Packet Guide
City of Charlottesville
Board of Architectural Review
Regular Meeting
August 19, 2025 5:30 p.m.
Hybrid Meeting (In-person at Council Chamber and virtual via Zoom)

Regular Meeting

RESPONSES TO PREVIOUS BAR COMMENTS

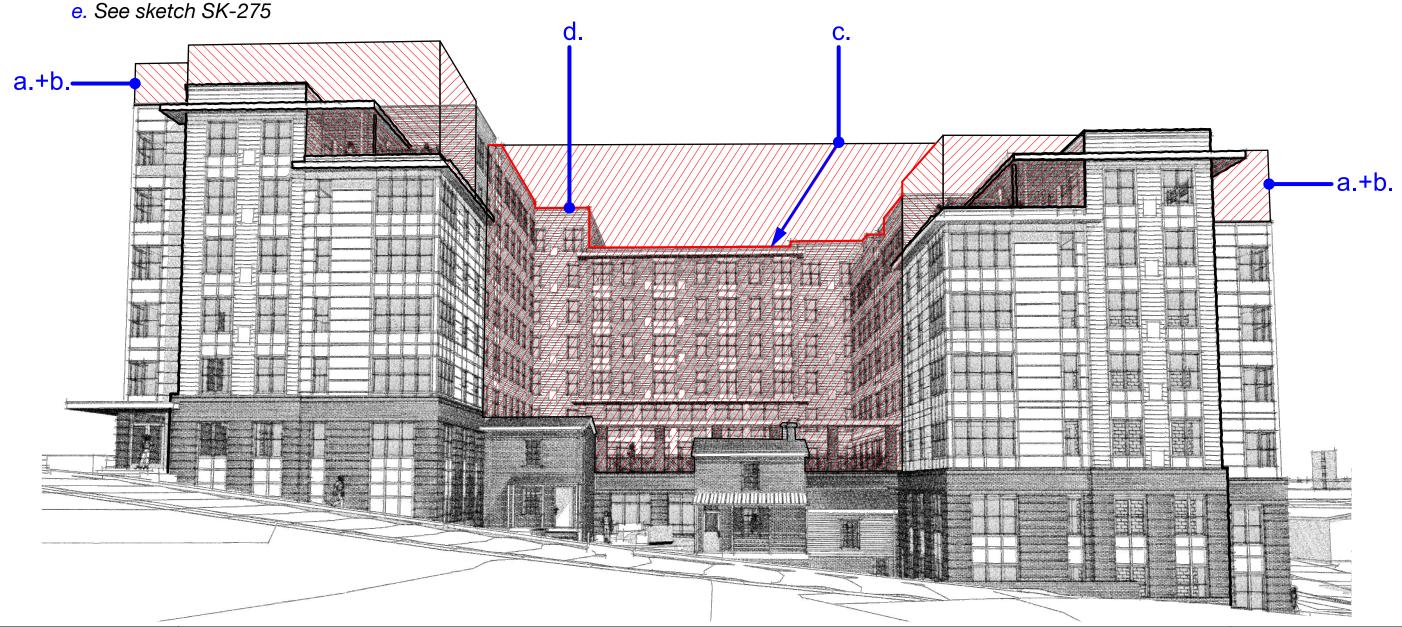
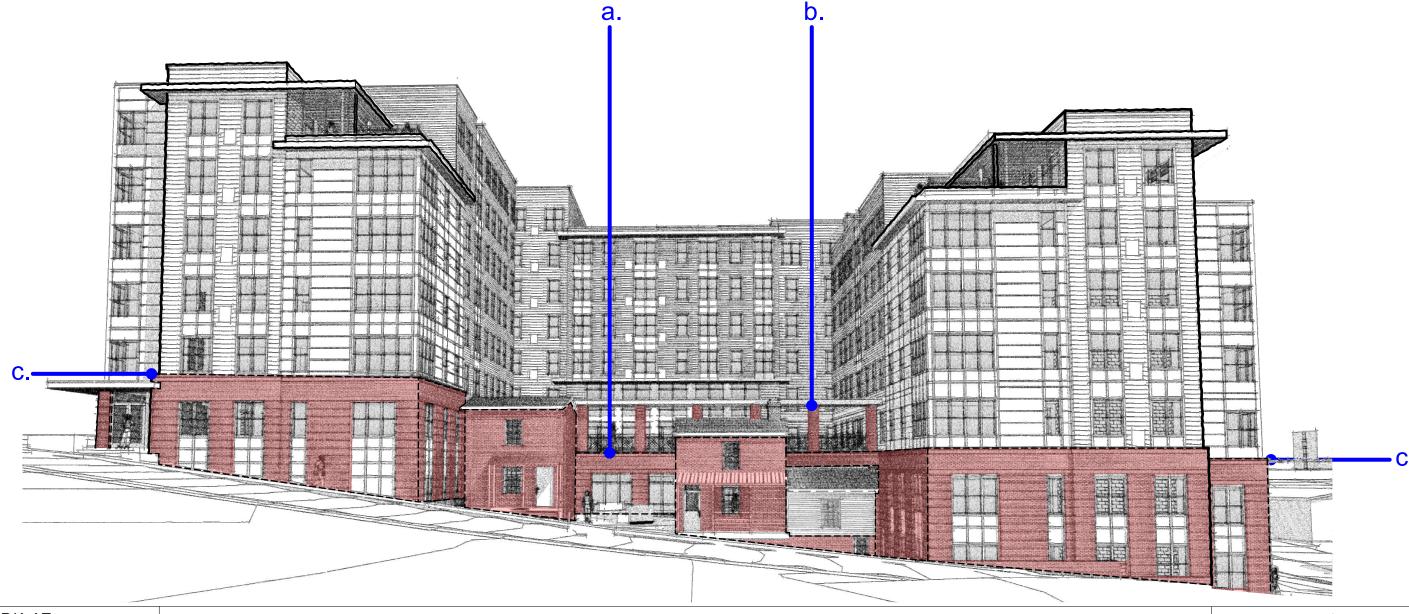
BAR COMMENT # 2: Articulate building facade to be more sympathetic to the scale of the houses.

- a. The building face immediately behind the houses is now lower than the house roofs.
- b. A brick colonnade and canopy provide greater facade transparency behind the houses.
- c. The entire street level elevation incorporates brick, fenestration and a consistent vertical scale to provide a more cohesive and regular pedestrian level street wall, consistent with the scale of the houses.

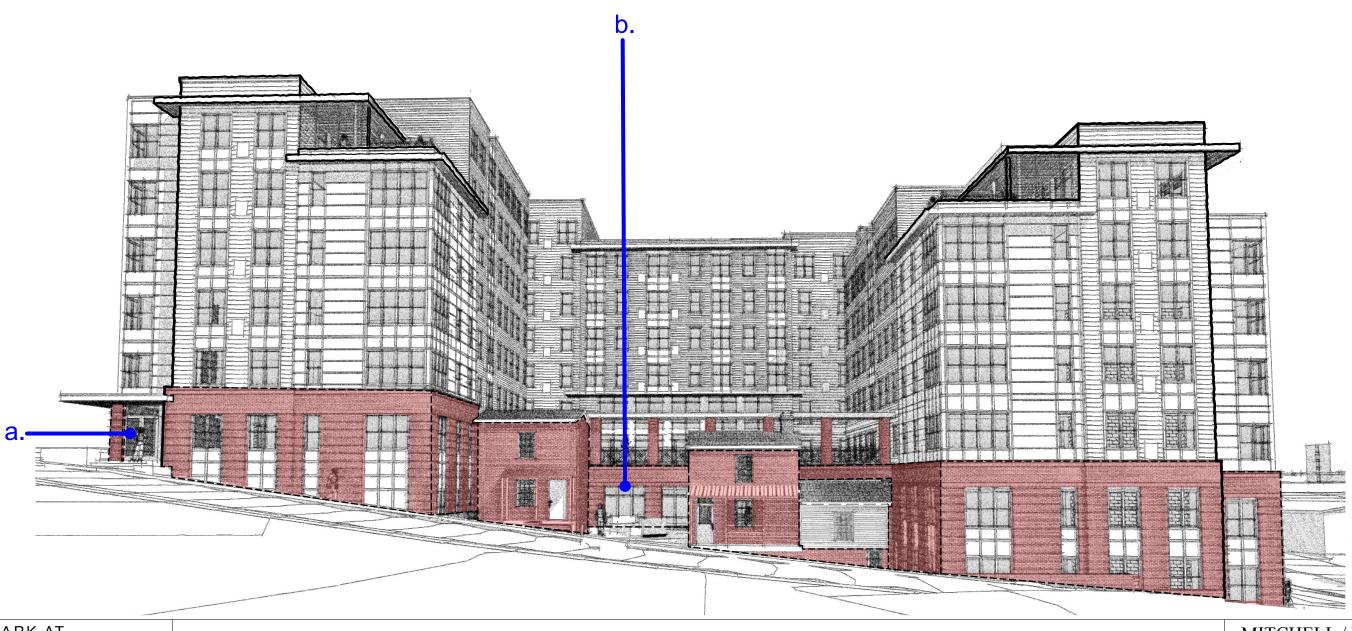
BAR COMMENT # 3: Could the entrances be moved?

Response: Yes

a. The primary entrance has been moved from its old location (b) to the NW corner (a) to provide more direct and convenient access to West Main St.

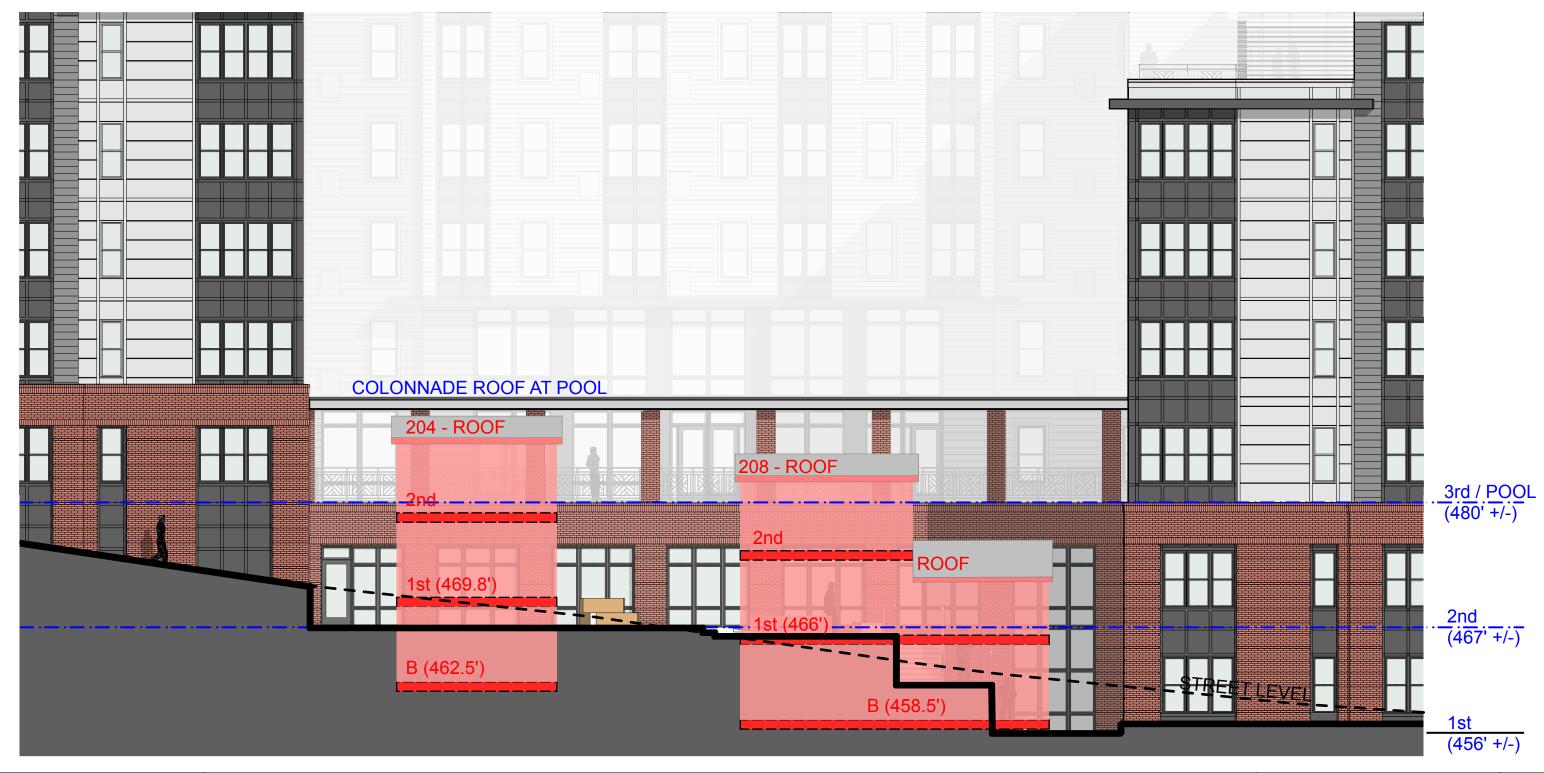
BAR COMMENT # 4: Develop courtyard space with properly scaled trees and make exterior an extension of interior amenity space.

Response: We agree
